11331.2 TEST WELL DATA 1984 (83)

Subj: N.A.C.I.P. Confirmation Study; construction of monitoring
wells for

Subject: Issuance of Variance to
Well Construction Standards
Camp Lejeune
Onslow County

Re: Contract N62470-83-C-6106, Confirmation Study; Evaluation of
Data From First Round of Verification Sample Collection and
Analysis, Marine Corps Base, Camp Lejeune

FIGURE A-1
MONITORING WELL CONSTRUCTION

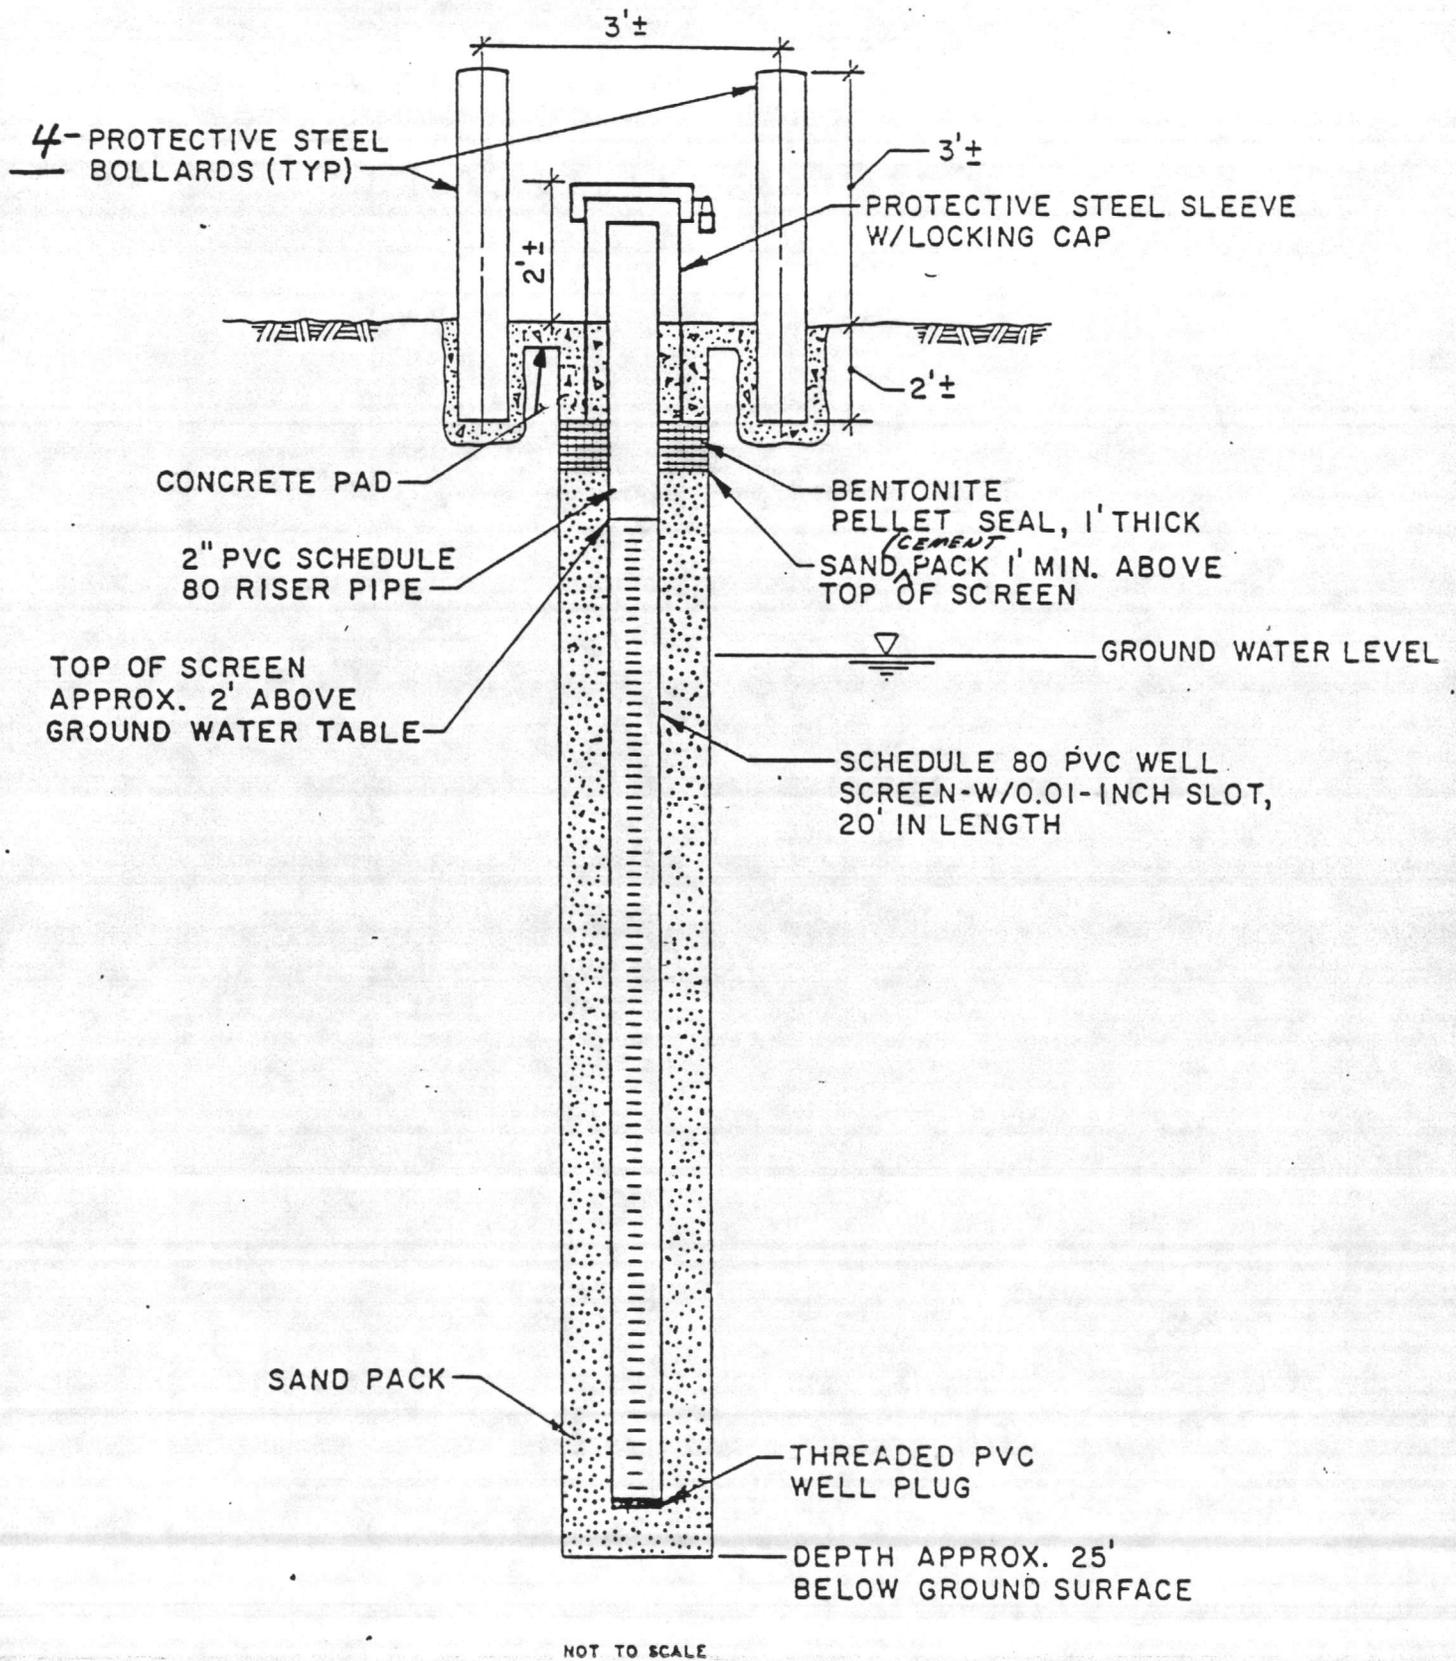
Well construction is shown in Figure A-1. At least one drill should be mounted on an All-Terrain-Vehicle (ATV) for access to remote areas. Each rig will use necessary tools, supplies and equipment and supplied by the contractor to drill at each site. Drill crews consist of an experienced driller and a driller assistant for work on each rig. A geologist, experienced in hazardous waste site investigations, shall be on-site to monitor the drillers efforts and for air monitoring/safety control. Additional contractor personnel will transport water to the rigs, clean tools, assist in the installation of the security and marker pipes, construct the concrete aprons and use a portable water pump to activate the wells. Unless otherwise specified, all water used/removed in this effort shall be allowed to seep back into the ground at each drill site.
